WELL API NO.
30-025-29131

7. Lease Name or Unit Agreement Name
SEVEN RIVERS QUEEN UNIT

SUNDRY NOTICES AND REPORTS ON WELLS

SEVEN RIVERS QUEEN UNIT #065 (309557)
LINN OPERATING, INC. (269324)
PROPOSAL TO PLUG AND ABANDON

NM Schematic

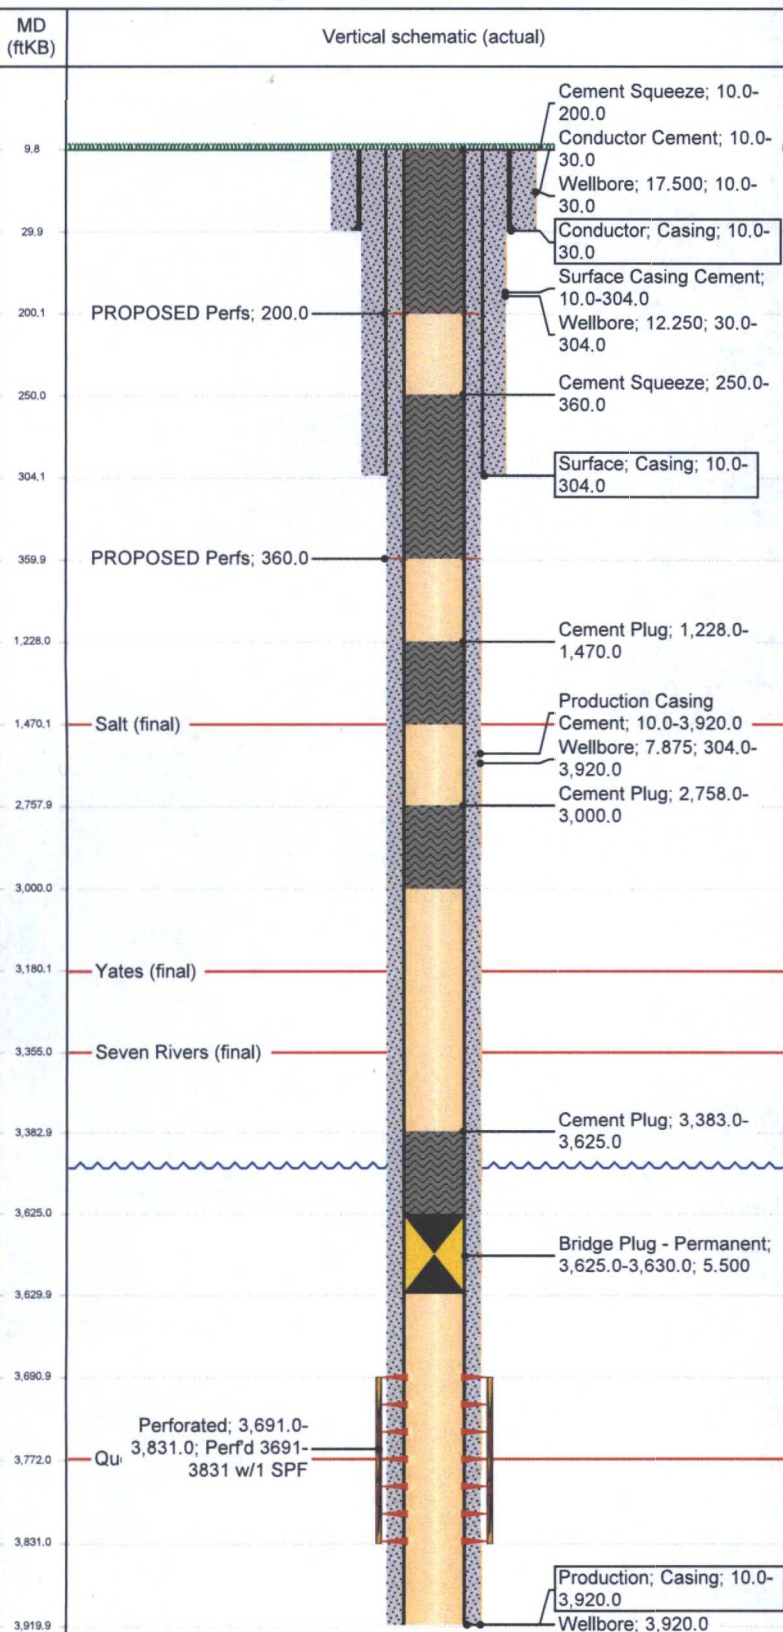
1. Set 5-1/2" CIBP @ 3625' w/25 sxs cmt
2. Circulate hole w/mud laden fluid. *Pressure test csg. Report results*
3. Spot 25 sxs cmt @ ~~3000' - 2758'~~ *3100'*
4. Spot 25 sxs cmt @ ~~1470' - 1228'~~ *1520'*
5. ~~Perf & Circ.~~ cmt @ 360' - ~~250'~~ *WOC & Tag. to surface*
6. ~~Perf & Sqz 75 sxs cmt @ 200' & circulate to surface.~~
7. Cut off wellhead and weld on Dry Hole Marker.

Verify cement to surface
